SERVICE LETTER

SEL-24-02

ELECTRICAL POWER - CONTACTOR REPLACEMENT

SK210-173A

Figure 1. 28-Volt Starter Contactor Replacement (Sheet 1)

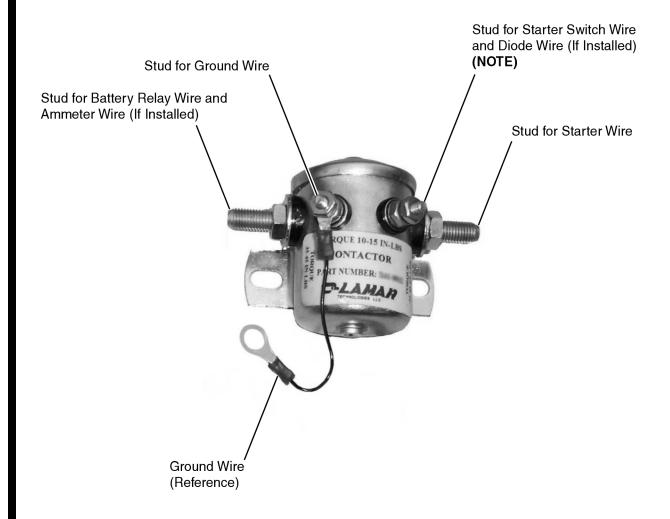
- 3. (Refer to Figure 1.) Remove and discard the 28-volt starter contactor. Keep the hardware that attaches the starter contactor to the firewall. (Refer to the applicable sections of the Service Manual.)
- 4. With the kept attachment hardware, install the new P52-0016 28-Volt Starter Contactor to the firewall. (Refer to the applicable sections of the Service Manual.)

CAUTION: Make sure that you install the wires to the same terminal studs as shown in Figure 1. If you install the wires in a different configuration than the one shown in Figure 1, damage to the system may occur.

NOTE: Do not install the ground wire to this stud.

FIGURE:

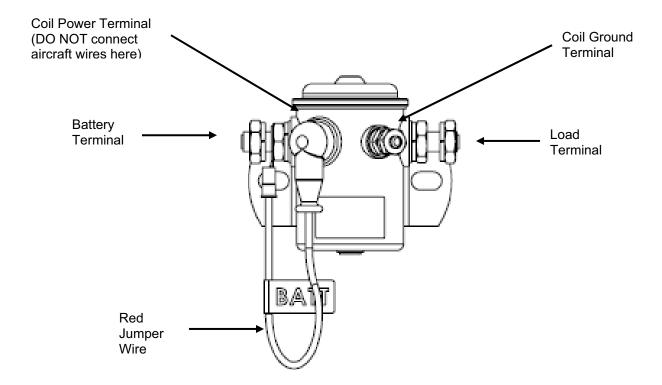
INFORMATION: Reference Figure shown below. The Lamar contactor kit will come with a red jumper wire

installed from the Battery Terminal to the Coil Power Terminal. This jumper shall convert a 4 terminal contactor for replacement of a 3 terminal contactor. 3 terminal contactors (S1579 and S1580) have this connection inside the contactor without a coil power terminal. Aircraft wiring must control (on or off) the contactor coil through the Coil Ground Terminal and not

have any wires (except jumper) attached to the Coil Power Terminal.
